CITY PLAN COMMISSION STAFF REPORT

Oak Park Townhomes

Hearing Date November 17, 2020

Item	Case	Request
#5.1	CPC-2020-00116	Area Plan Amendment
#5.2	CPC-2020-00091	Rezoning with plan
#5.3	CPC-2020-00159	PIEA Plan

1 SITE PLAN
SCALE: 1"=30'-0"

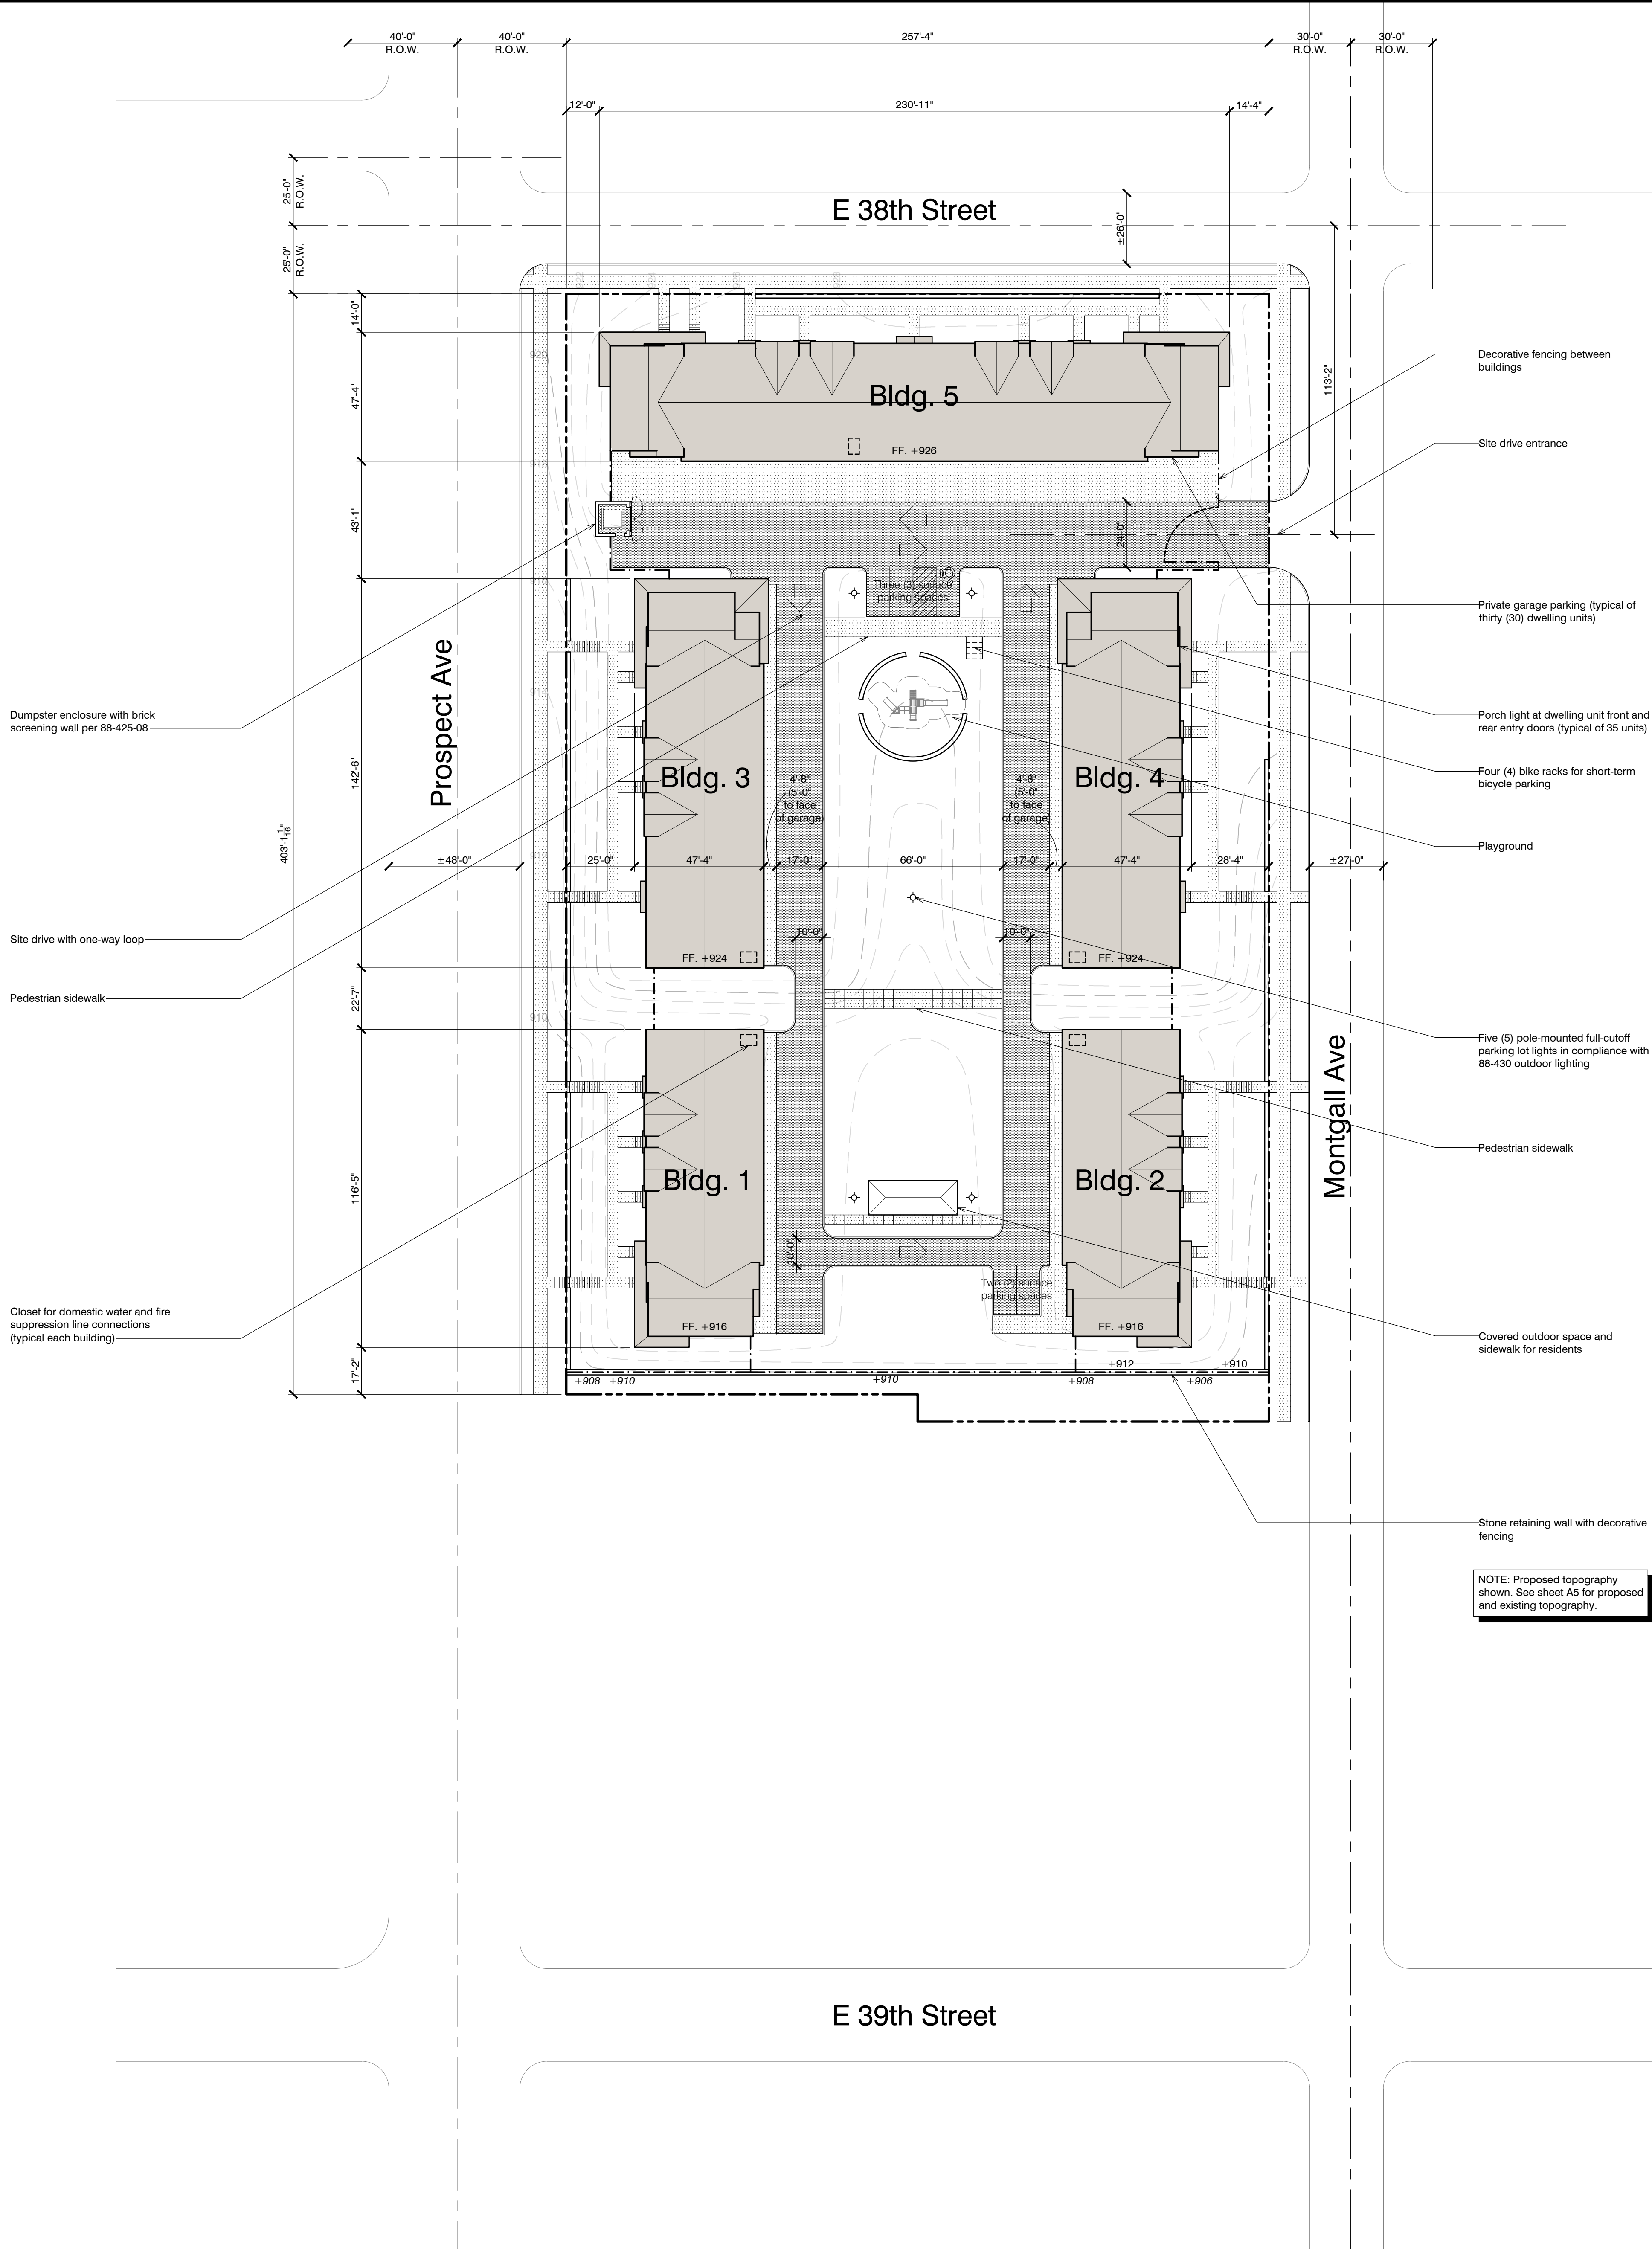
Access to the development is proposed via a single driveway off Montgall with a circular drive around the courtyard. The plan also shows a playground and a covered outdoor space. The plan provides 30 private garages with 5 outdoor parking spaces.

The submitted plans shows two story townhomes constructed of brick, with horizontal lapping accented with painted wood siding and asphalt shingles. The plan did not include architectural building elevations calling out specific materials. The plan also shows a gate at the main driveway. Staff recommends that the gate be recessed a minimum of 20' from the property line to allow for a car to be clear of the sidewalk.

Due to the grade change, the pedestrian walkways have stairs that connect to internal sidewalks that eventually connect to the public sidewalks. Staff recommends that additional pedestrian access be provided on Prospect Avenue and Montgall Avenue.

The plan shows 35 parking spaces which is the exact number of spaces required by the Zoning and Development Code. 30 spaces are within garages and there are 5 spaces outside. Staff is concerned with parking within the courtyard as it may impede movement.

The plan provided for private and public sidewalks. Staff recommends additional connection on the east and west sides.

- f. Provide phasing information on the face of the plan.
- g. Revise plans to provide direct access from the public street to the courtyard from Prospect Avenue and Montgall Avenue.

Planting Legend	
Trees	Shrubs
 <i>Ostrya virginiana</i> (Eastern Hop Hornbeam)	 <i>Taxus x media 'Hicksii'</i> (Hicks Yew)
 <i>Nyssa sylvatica</i> (Black Tupelo)	
 <i>Cercis canadensis 'Forest Pansy'</i> (Eastern Redbud)

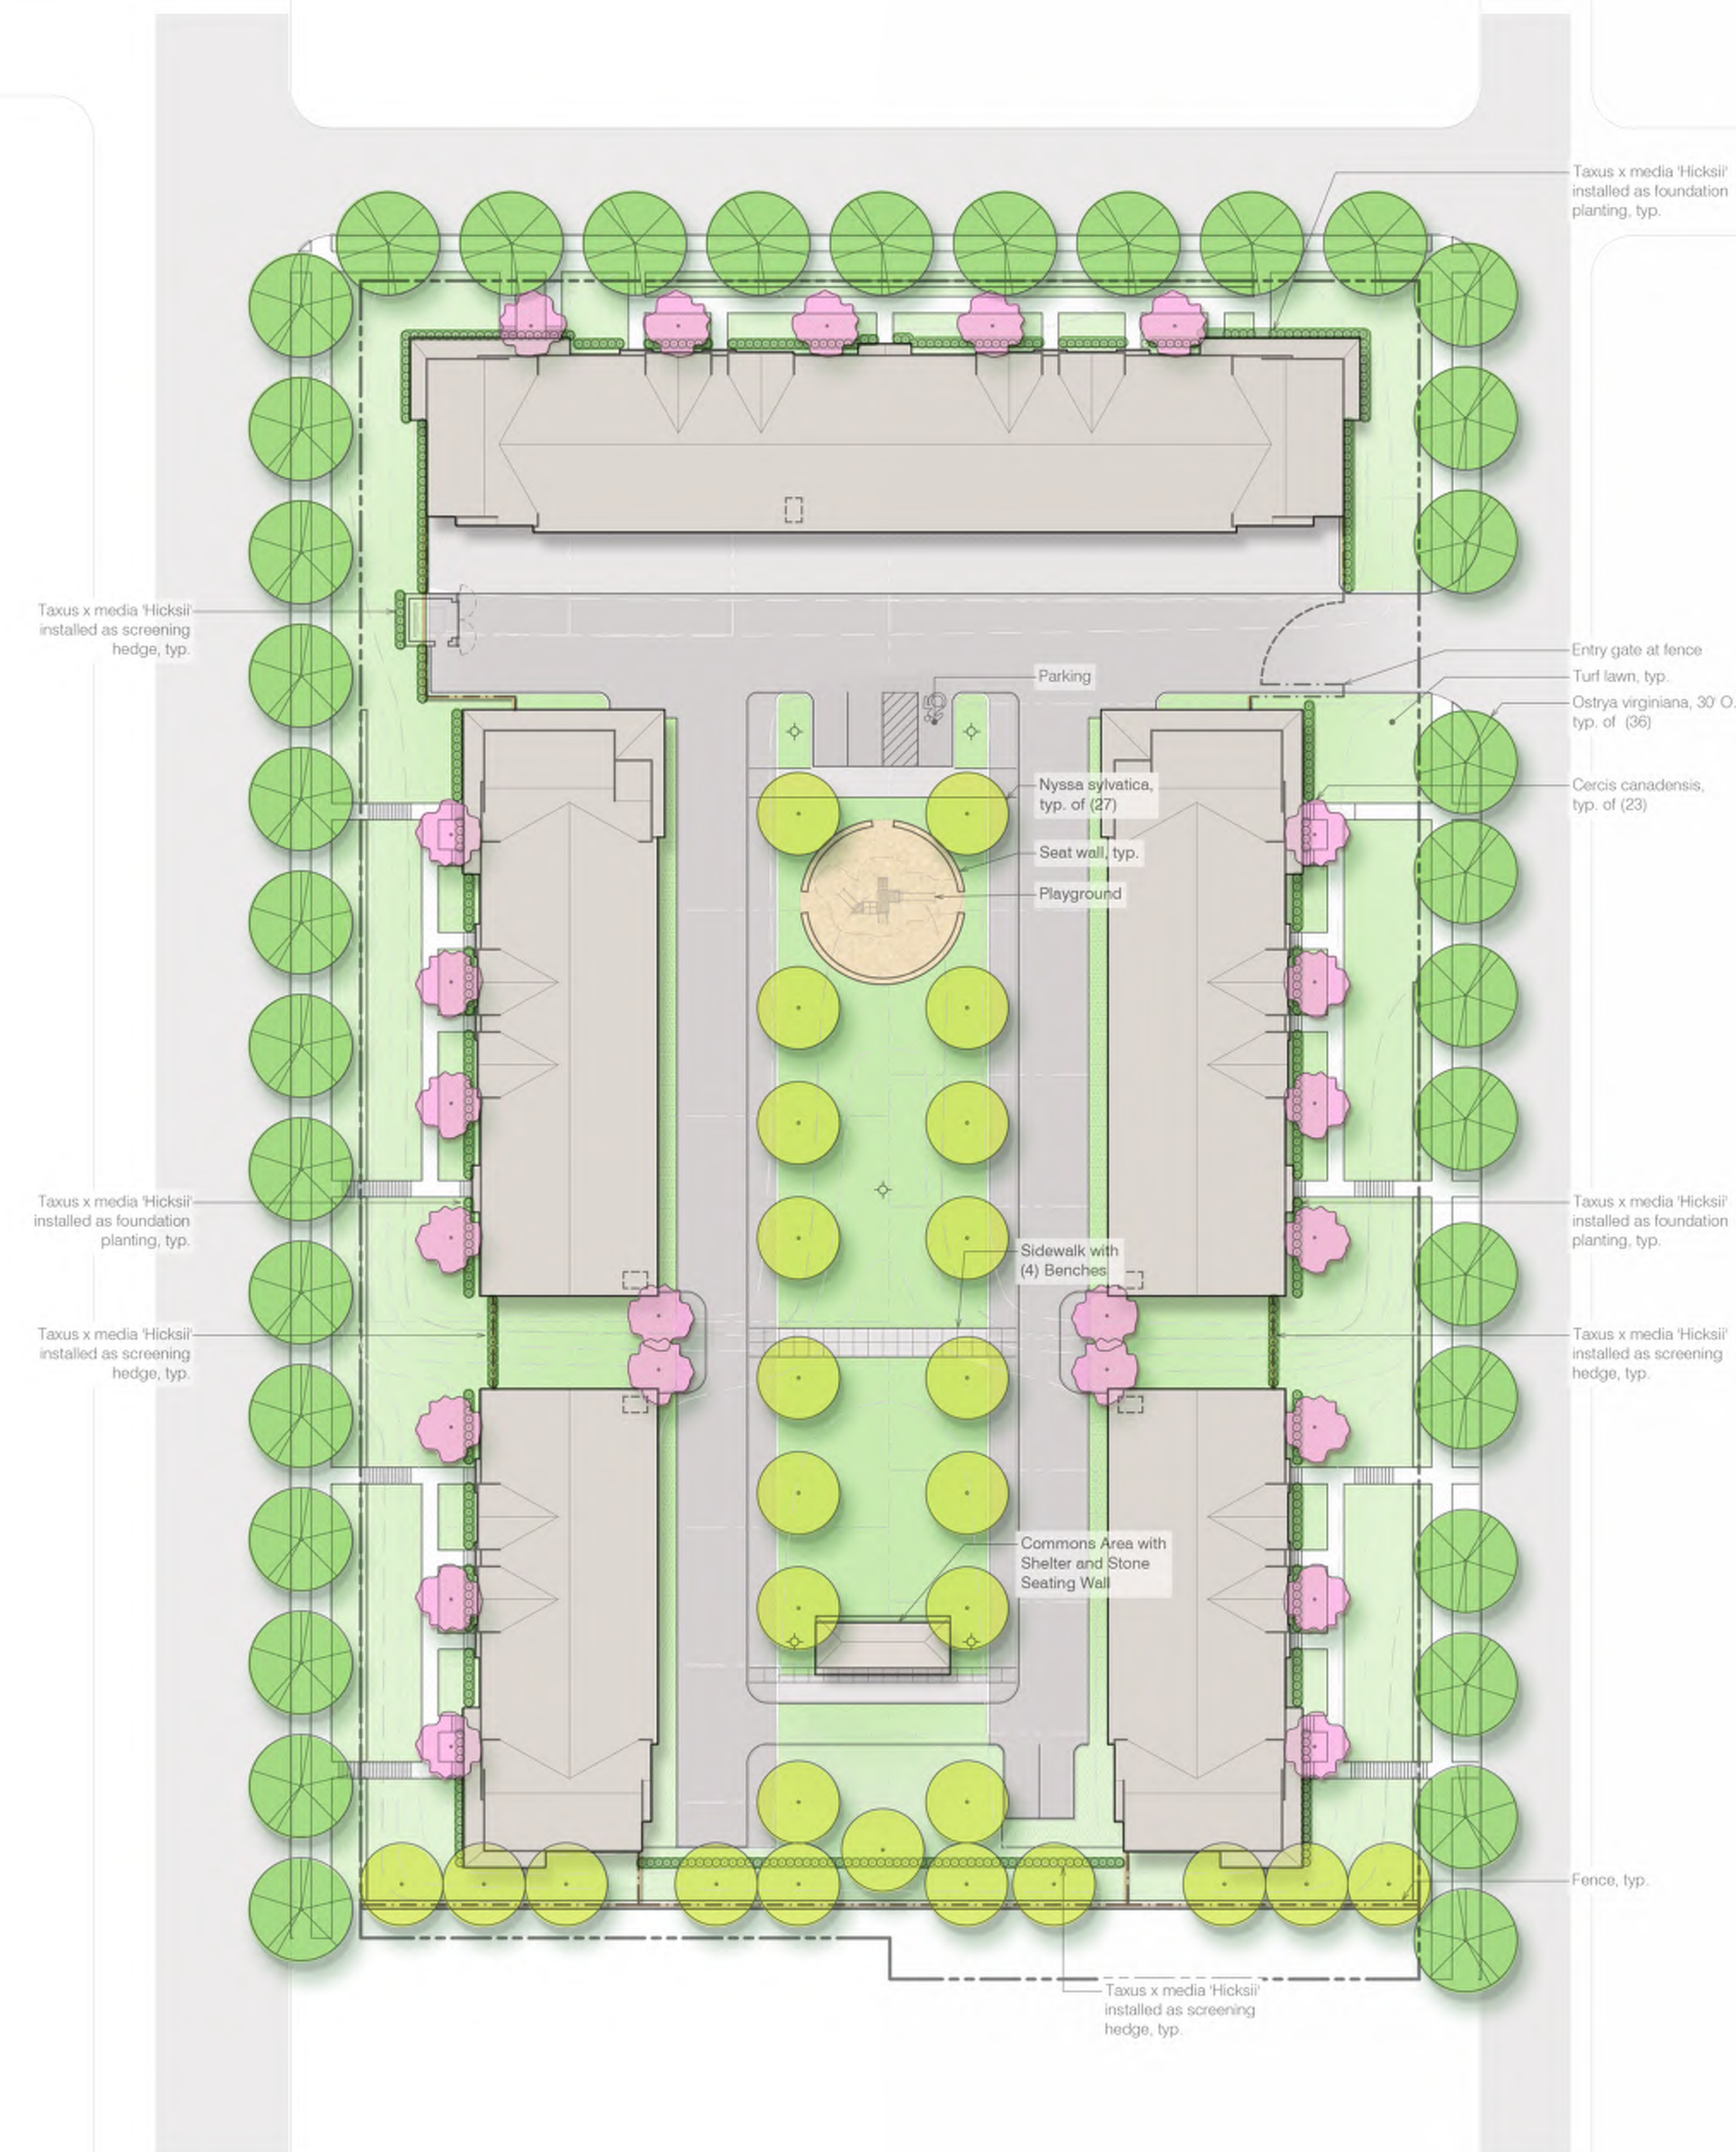
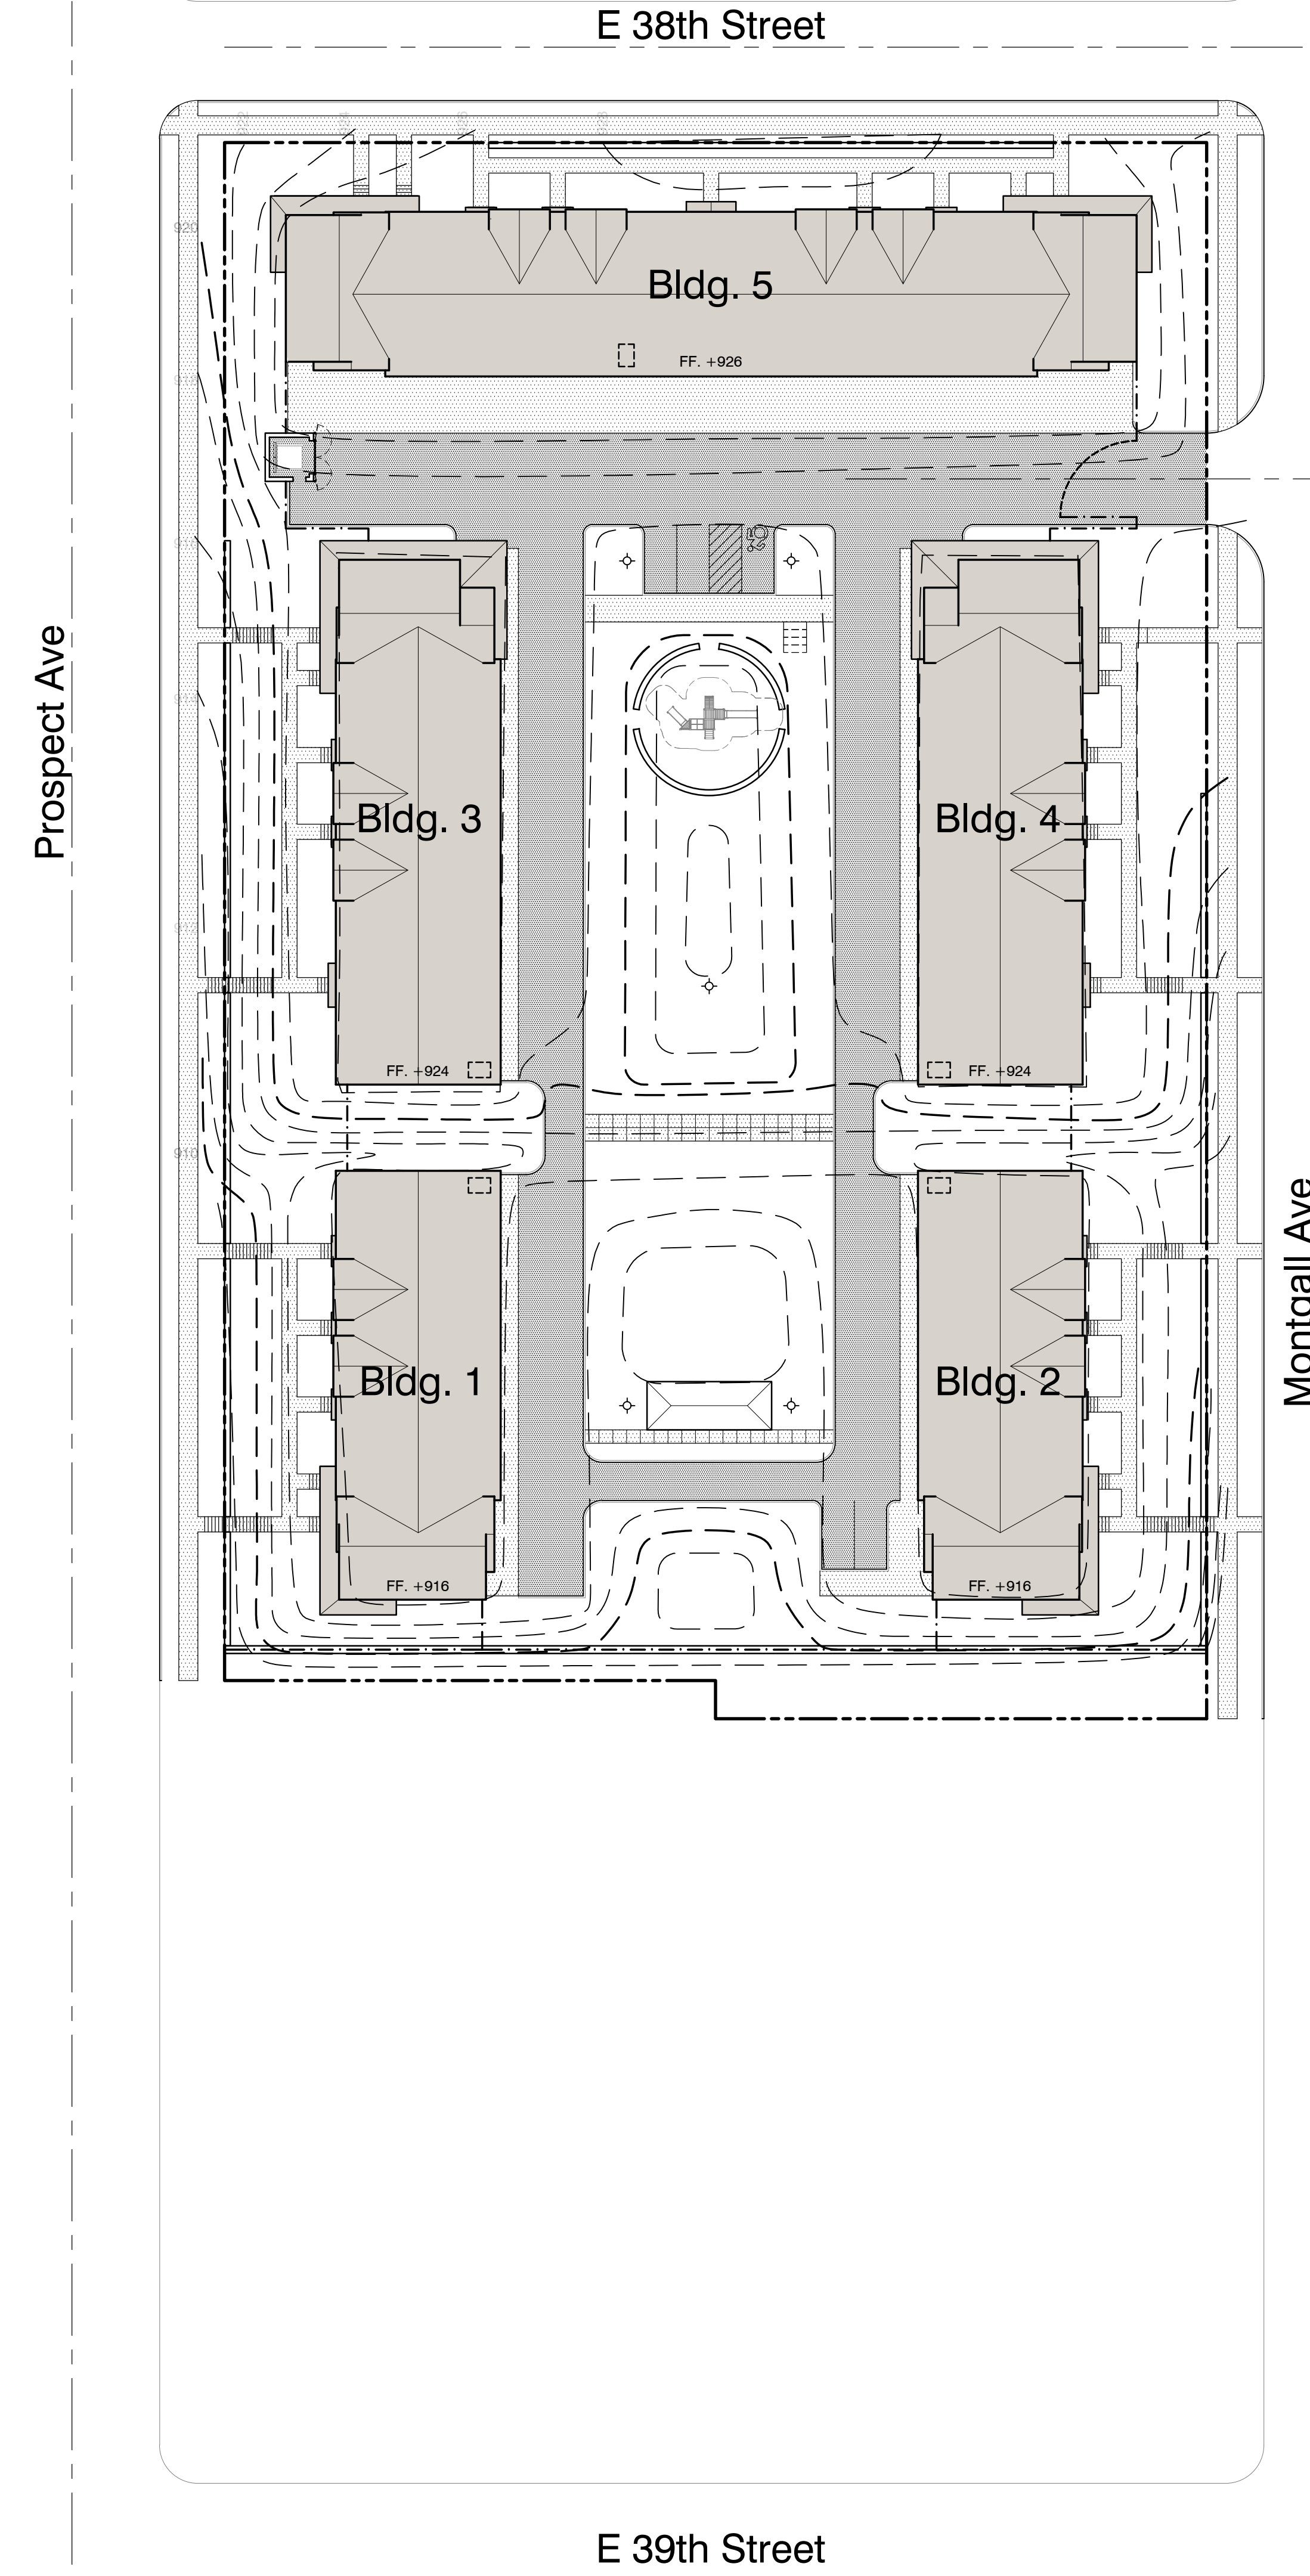
A preliminary landscape plan has been prepared by the applicant indicating street trees and shrubs along public streets per the requirements of the Zoning and Development code. Staff recommends that additional landscaping and berms where possible be provided to provide additional buffer screening around the rear of the dumpster enclosure. The final landscaping plan shall be reviewed with the final UR plan and shall include a detailed foundation planting scheme for each building.

- j. Incorporate more brick and where siding is used, use a cementitious low-maintenance materials.
- k. Show landscaping in compliance with general landscaping requirements of 88-425-04. Revise Plans and Resubmit
